Product Change Notification

Product Change Notification: PCN-24-201125

KILOVAC EV600 CONTACTORS

EV600 Before

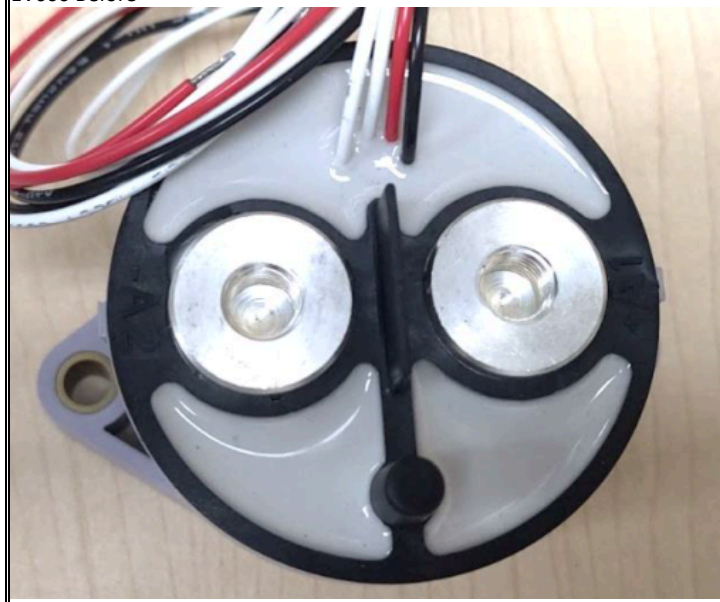
Dear customer, we hereby inform you about a change on the economizer circuit used on the EV600 contactors family. The change improves the PCBA making it more robust under overvoltage supplied to the economizer; in addition, we are incorporating a new Top Cap design for a better control on wires exit; in the same way the new top cap design will be suitable to reduce risk for insulation damage on the wires exit. Please be aware that the purchase order already placed to TE connectivity will have the updated economizer circuit, nevertheless, new top cap design will be incorporated for new PO's. Although change does affect the form of the product, the performance will not be impacted negatively. The new PCBA and Top Cap design, will be first article inspected and validated prior to any shipment.
